**SERVICE
INFORMATION
BULLETINS
2001**

Service Information

"Service per mouse click " (flash-programming, Digi 100 chassis)

Version of the PCB without CC80209

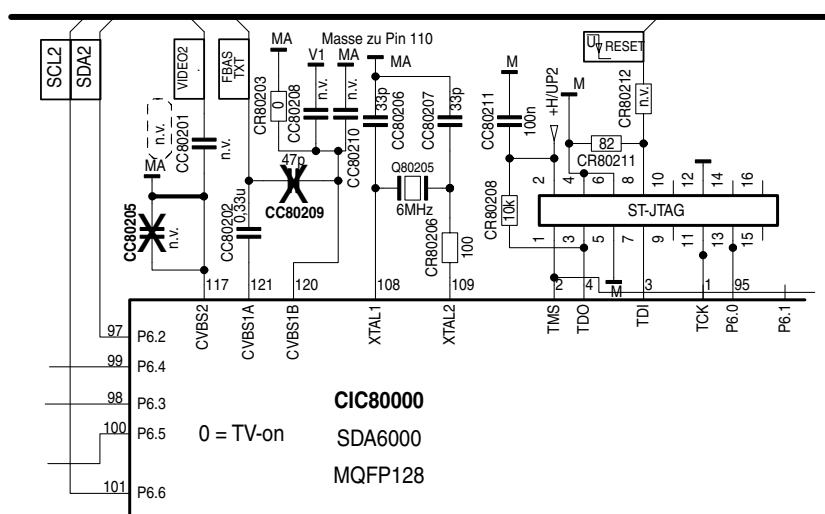
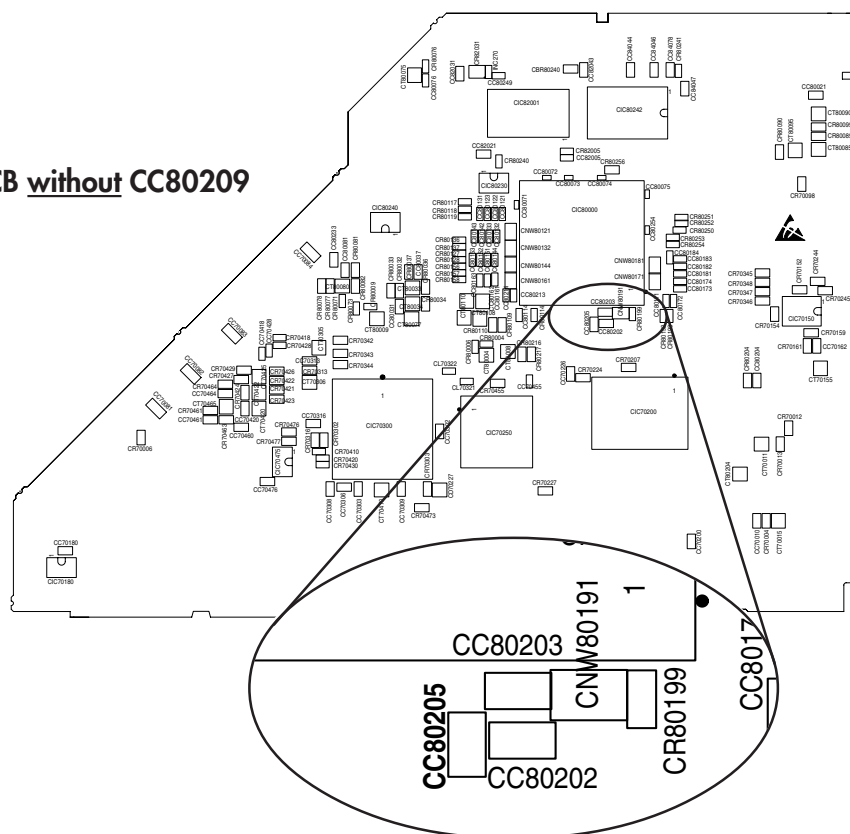
The TV set switches at times to standby and then after several seconds back to normal operation.

This failure may be caused by an uncontrolled oscillation of the CVBS input and a faulty software library of the processor.

To eliminate this failure it is generally necessary to update the unit's software. For this consult the table 1 (software assignment).

In addition it is necessary to check and change if necessary the circuit of the Feature module of older TV sets. TV sets and chassis which **do not** require a change of the circuit are listed in the tables 2 and 3. The positions of the serial numbers of the TV sets and chassis are described on page 4.

For the positions of the components concerned on the Feature module please see the circuit diagram excerpt and the PCB illustrations on page 2.

- Remove the chip capacitor CC80209 (coordinates x71/y78) if provided.
- Connect CIC80000, Pin 117 with ground (e.g. chip capacitor CC80205 (coordinates x71/y81), replace with a chip jumper, or solder in a wire bridge from Pin 117 to ground).
